Staff Report

Date: December 5, 2019

Re: PLNHLC2017-00722 – Modifications to New Construction Approval

PROPERTY ADDRESS: 613 E. 100 South

WEST ELEVATION 2
 SCALE: 3/16" = 1'-0" A201

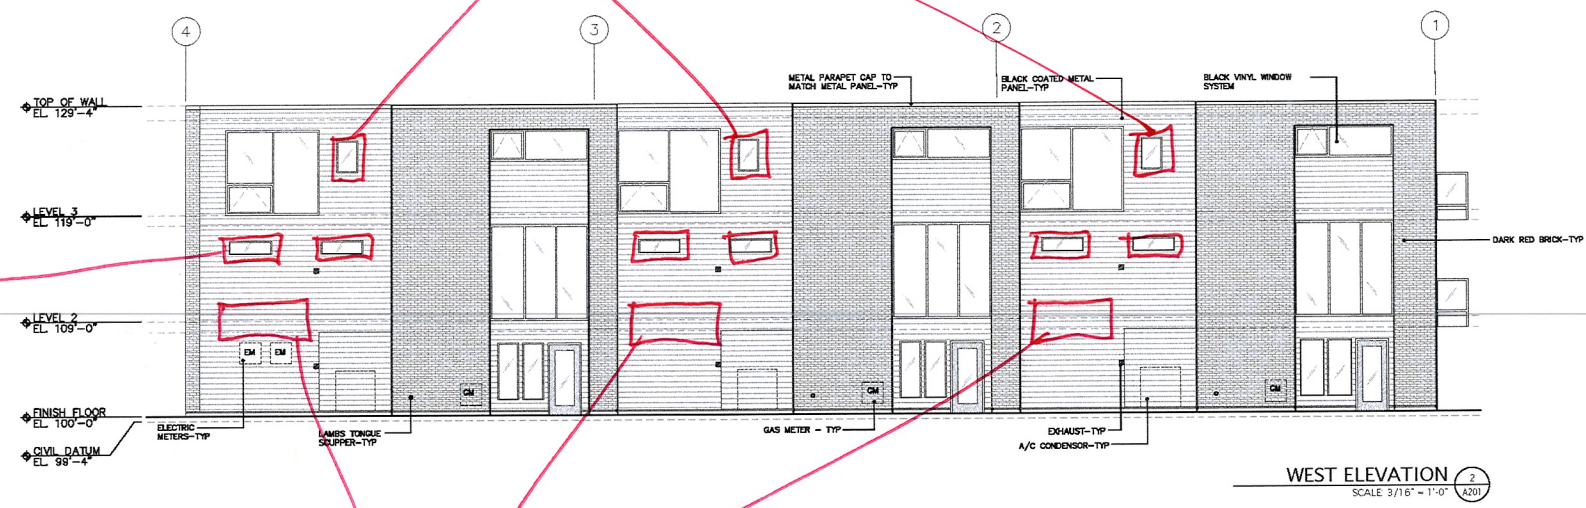
1. The omission of one (1) 8’9” x 3’ and two (2) 9’ x 10” awning windows (one per unit) on the ground floor of the building
2. The addition of six (6) 5’ x 16” aluminum clad wood fixed windows (two per unit) on the second floor of the building.
3. The enlargement three (3) fixed fiberglass windows from 3’ x 3’ to 3’ x 4’ feet (one per unit) on the third floor of each unit.

As explained in the applicant’s updated proposal, they would like to remove the first-floor windows on the west façade as they would open up to a utility room where mechanical equipment has been installed along the west wall. They would like to add the two windows on the second floor as these windows provide much needed light in each of the unit’s kitchens, where previously there was none. And they would like to slightly increase the size of the windows on the third floor to provide more light in each of the unit’s showers.

Change size from 3'x3' to 3'x4'

Add 5'x16" Kitchen windows

Remove 8'9" x 3' utility / flex room windows

For these reasons, staff asserts that the modified proposal remains in line with the historic new construction standards and guidelines and is recommending approval.

1. Modifications to the South (Front) Façade

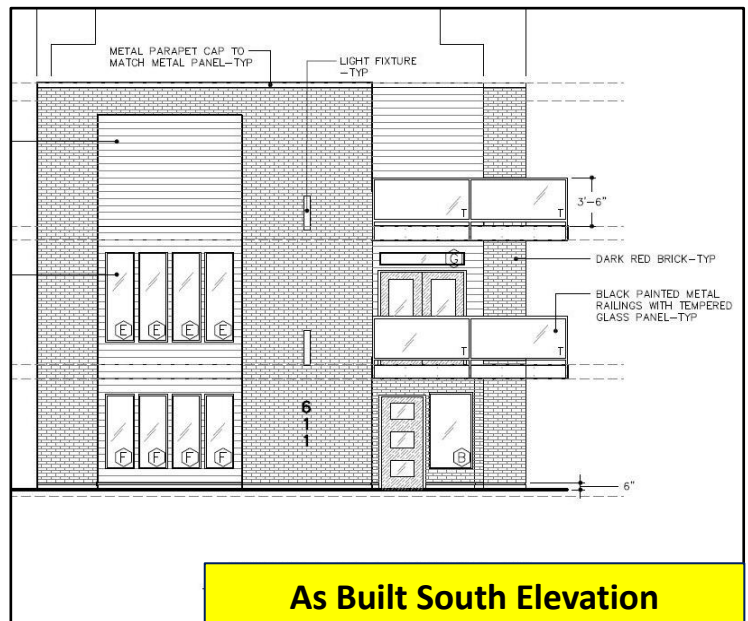
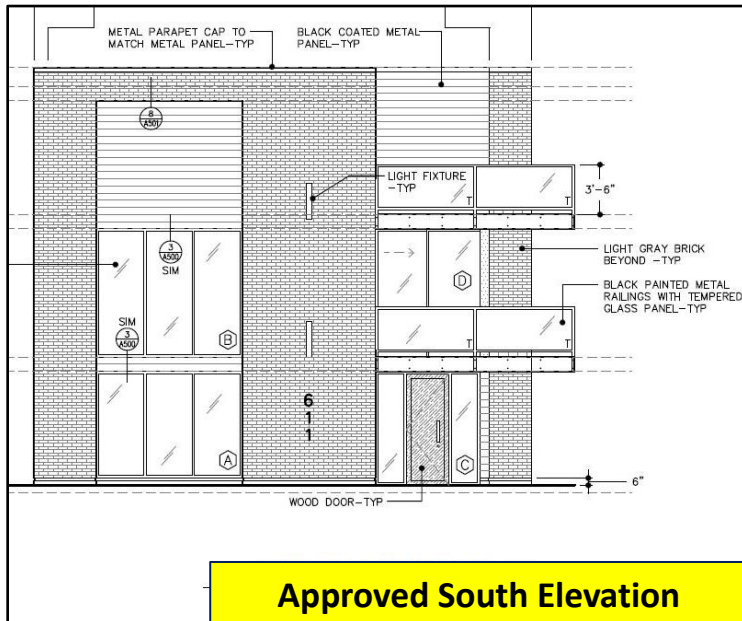
- The two rows of windows on the left building plane have changed in configuration and dimension from a tripartite arrangement (10’4”w x 7’6”- 9’h) to four smaller side-by-side vertically emphasized fixed casement windows (8’6”w x 5’5” - 6’6”h total).
- All of the window material has changed from fiberglass to vinyl

- Deny the request to change the windows and sliding doors on the front façade
- Approve the request to change the front doorway design and material

2. Modifications to the East (Interior) Façade

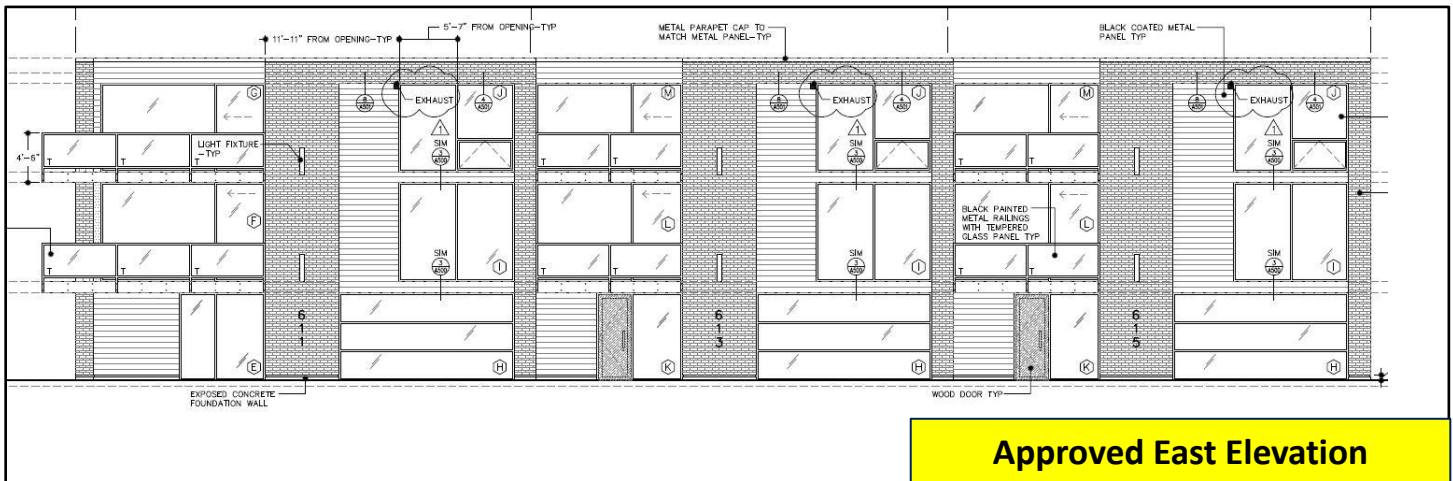
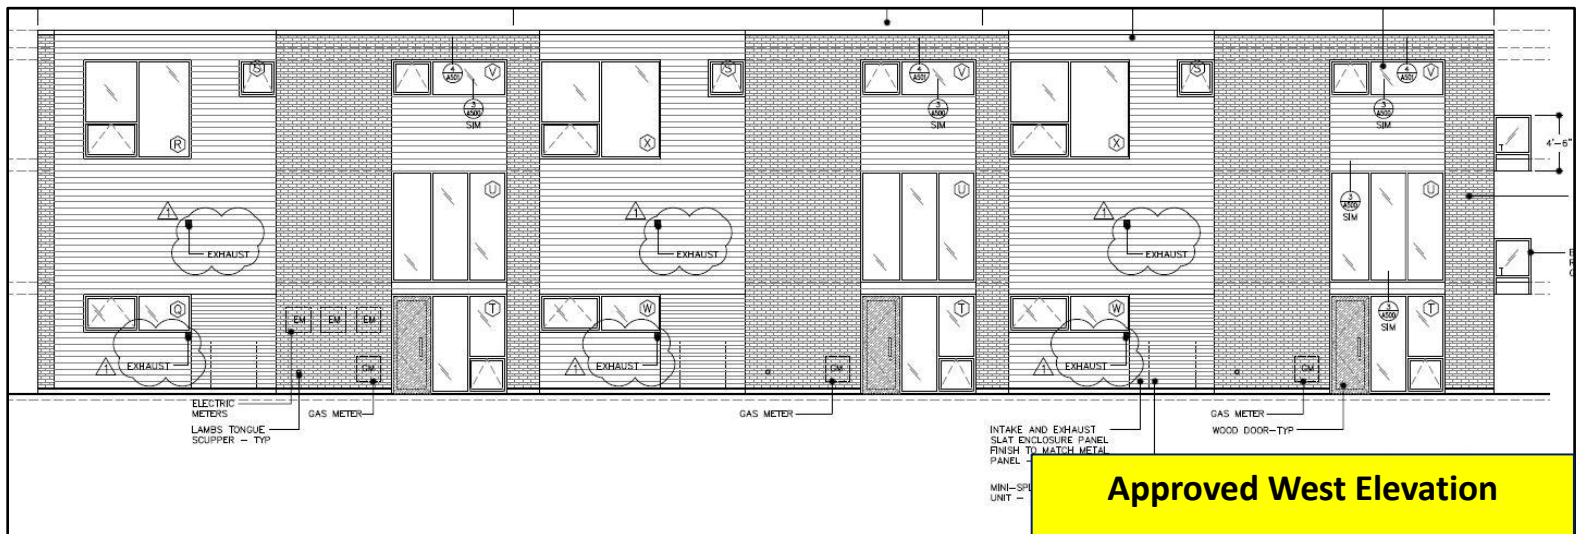
- Recessed building planes - The window/sliding door configuration off of the second and third-level balconies have changed in configuration and dimension to 3-5 side-by-side vertically emphasized casement windows
- Forward building planes - The window arrangements on the three building planes above the garage doors have changed in configuration and dimensions to four side-by-side vertically emphasized casement windows
 - Second level opening changed from 10'6" w x 9' h to 8'6" w x 6'6" h total
 - Third level opening changed from 10'6" w x 8' to 8'6" w x 5'5" total
- The windows beside the two front doors are smaller in height width
- All of the window material has changed from fiberglass to vinyl

- Different from the two doors shown on the as built elevation, the 9-foot sawn cherry wood doors are proposed to be replaced with 6'8" mahogany doors
- The glass panel garage doors are proposed to be replaced with black flat panel steel garage doors (see [Attachment B](#) for all material detail)

- Deny the request to change the windows and doors on the second and third floor of the east façade
- Approve the request to reconfigure the front doorway design and door material on the ground floor of the middle and rear units
- Approve the request to replace the glass panel garage doors with steel panel garage doors

reconfiguring the front doorway design would not be detrimental to the character of the rest of the building and is recommending approval of this modification as seen on the as built drawings. Similarly, the change in garage door material from glass panel to steel panel would not greatly affect the overall character of the building, which is why staff is also recommending approval of this additional request.

3. Modifications to the West (Interior) Façade

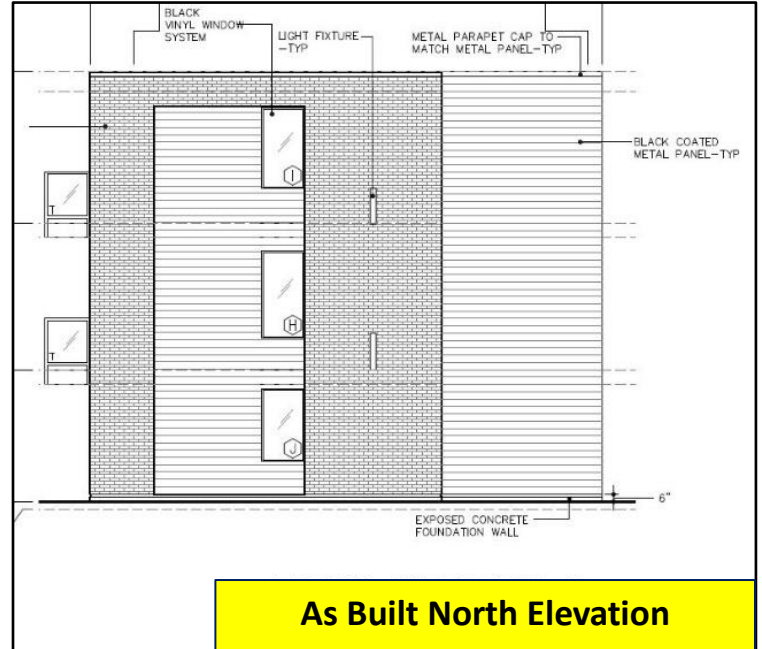
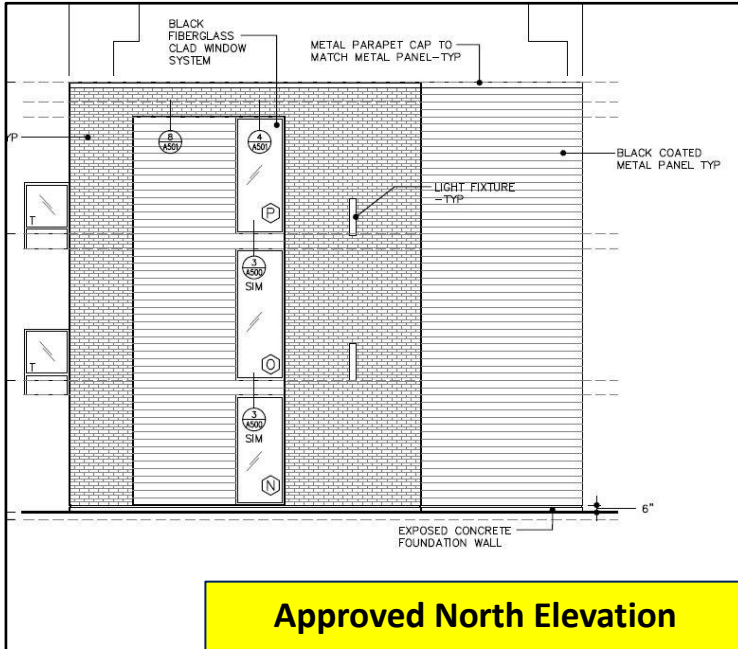
The amount of glass on this west façade has been significantly reduced from the original proposal creating an unbalanced solid to void ratio. This may be more apparent on this façade as it is not as well articulated as the east. The relationship of the width to the height of the windows is not visually compatible with the surrounding structures on the streetscape, which is something that the historic new construction standards require. Because of these reasons, staff is recommending denial of the request to modify the windows on the second and third floor of the building. However, as the back doorways are recessed and not very visible from the public way, staff concludes that reconfiguring the back doorway design would not be detrimental to the character of the rest of the building and is recommending approval of these modifications as proposed on the as built drawings.

- Deny the request to modify the windows on second and third floor of the west façade
- Approve the request to reconfigure the back doorway design and door material on the ground floor of all three units
